# Recall Bulletin

**SUBJECT:** Front Axle Right Half Shaft Fracture

**MODELS:** 2013-2014 Chevrolet Cruze  
Equipped with 1.4L Turbo Engine (LUV)

**Service Part Number 13334705, 13367771, 13335132 (Auto Trans solid shaft) and 13367770 (Manual Trans solid shaft)**

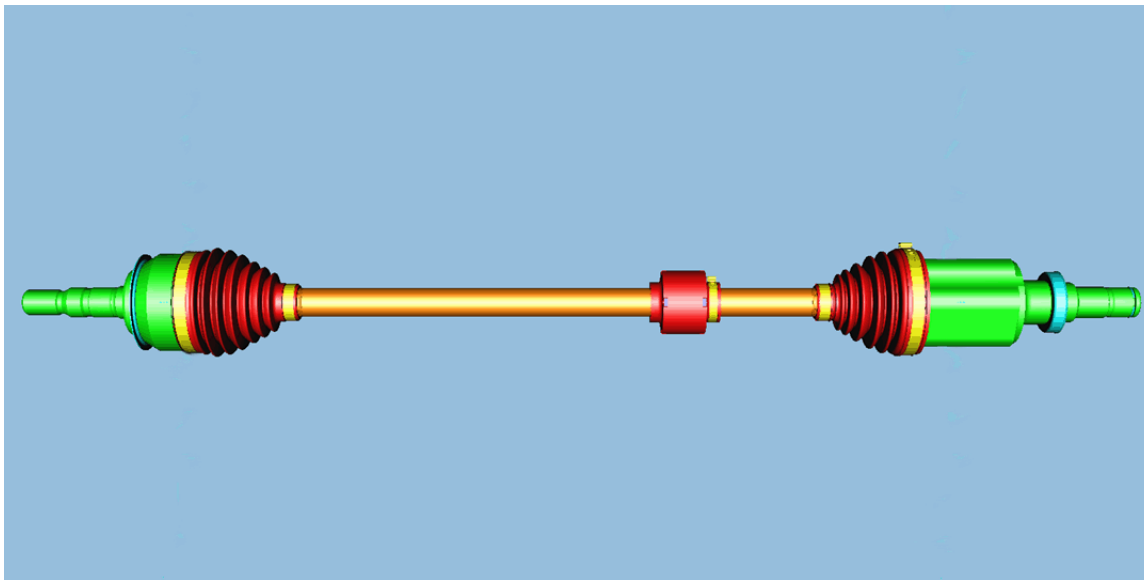
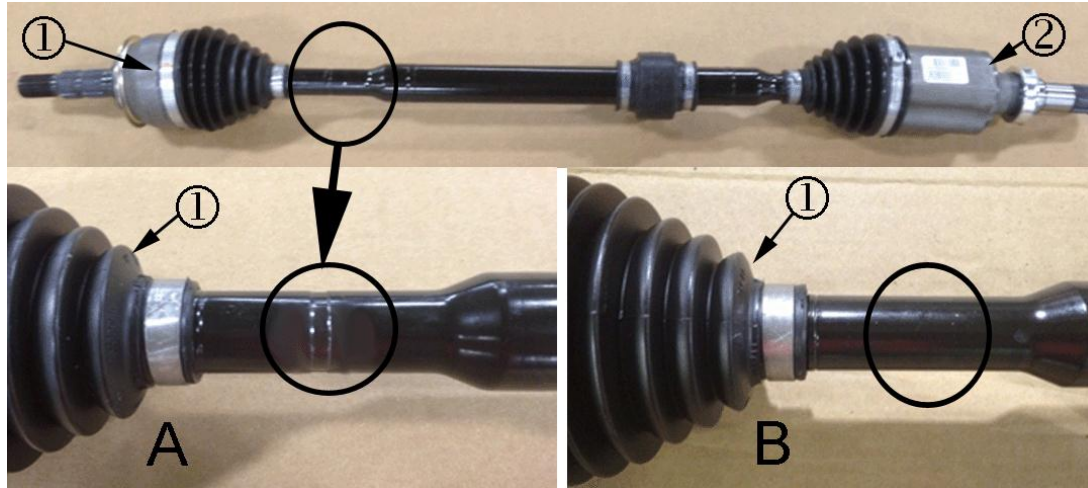
The service part inspection for part numbers 13334705, 13367771, 13335132 (auto transmission) and 13367770 (manual transmission) has been revised. All solid axle shafts are good stock and can be used for the repair.

**Note: Any additional paint marks found on a solid axle shaft can be disregarded.**

1. The outboard side of the half shaft (longer portion of shaft between CV joint and isolator) is a solid painted bar shaft. Same diameter across entire shaft. There are no other identifications on the half shaft to look for. This part can be used for service.
